P P514965

SEWAGE DISPOSAL SYSTEM HOWARD COUNTY HEALTH DEPARTMENT BUREAU OF ENVIRONMENTAL HEALTH 410-313-2640

SUBDIVISION Choi Property LOT NUMBER 21 ADDRESS 3332 Danmark Drive

CHOI PROPERTY
LOT 21
PLAT# 10632
HOWARD COUNTY, MARYLAND

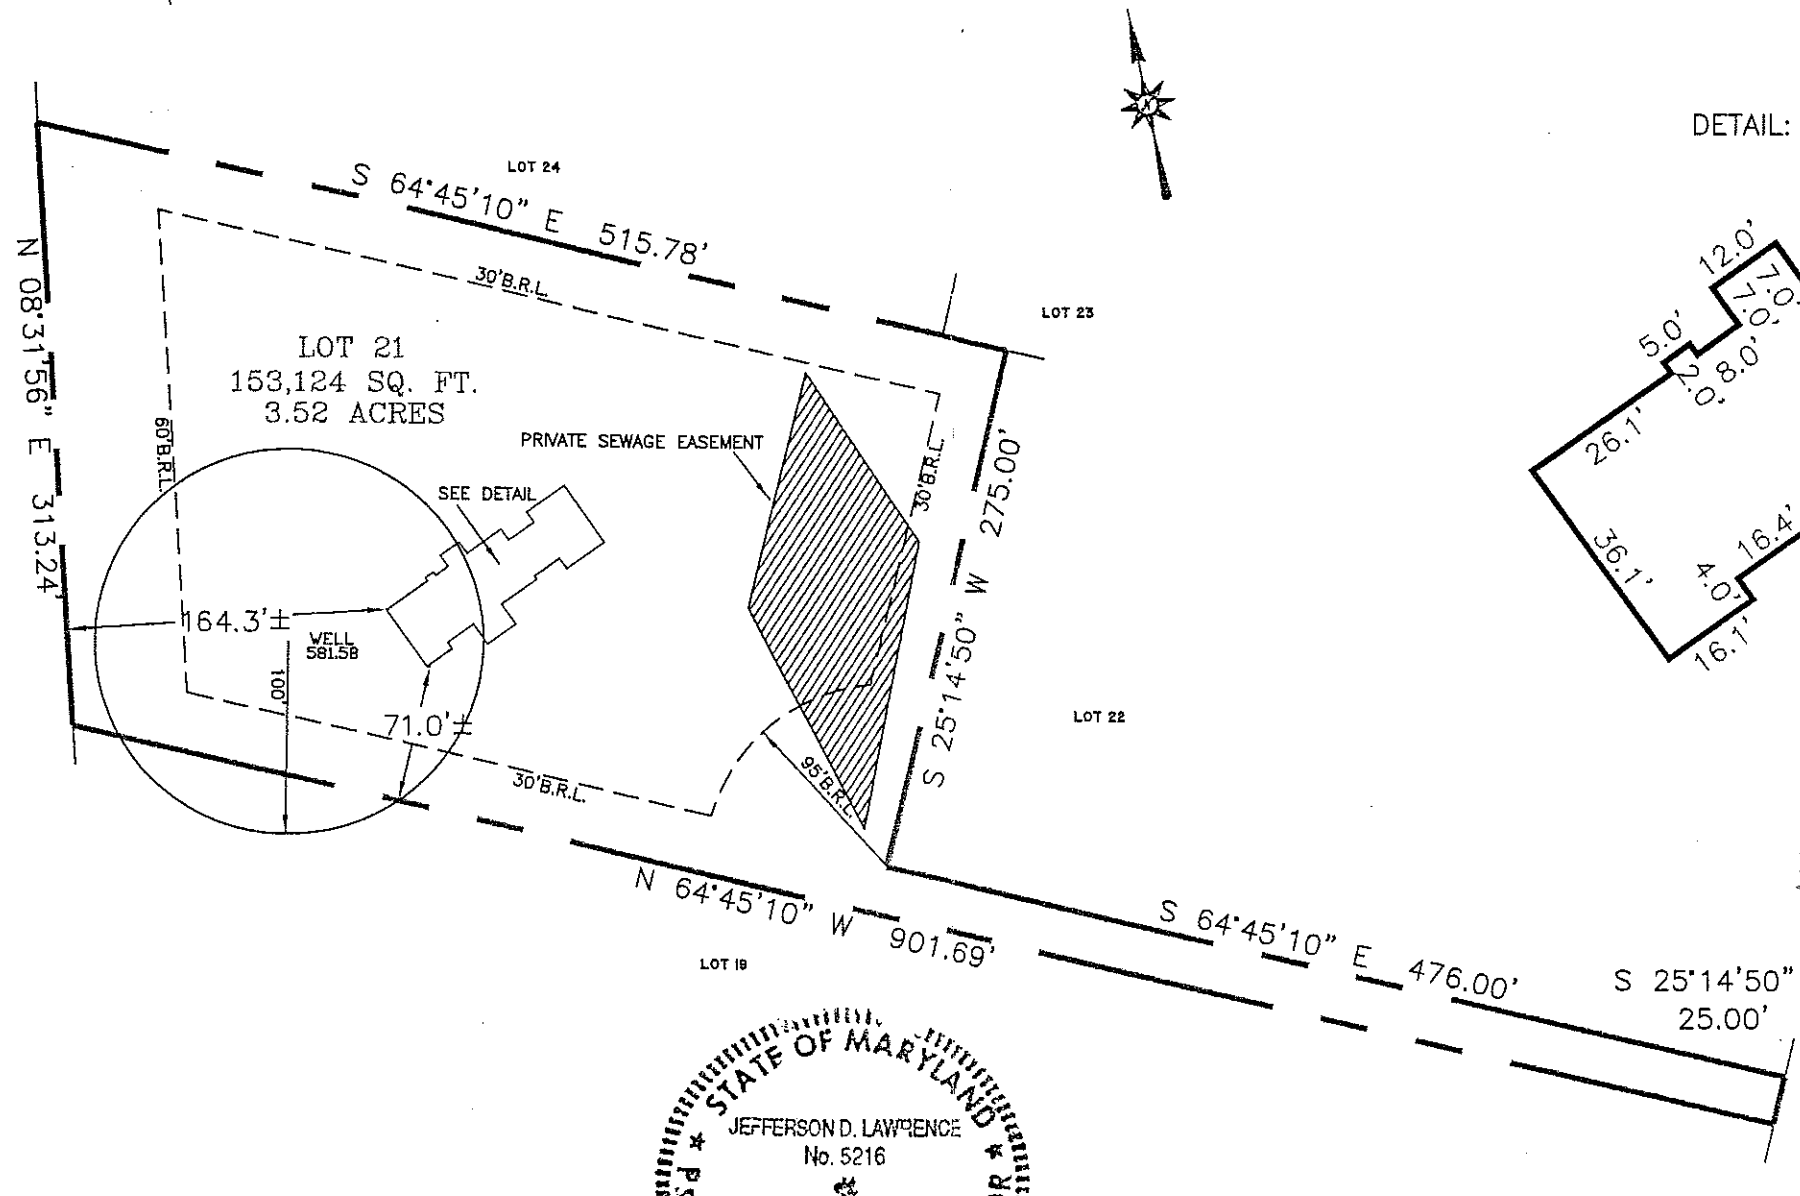
Trenches should be 7' edge to edge (10' center to center) to conserve future septic area. - This is for this job only! Assuming contour allows.

PRE-CONSTRUCTION INSPECTION: 3/30/01 Contour similar to BP plan. OK to put in system as per plan and 7' trench spacing. Contractor to gravel pipe

INSPECTION COMMENTS: under driveway and leave beginning and ends of trenches open (BB) 4/2/01- OK TO COVER ALL WORK, WPI OK - (SRK)
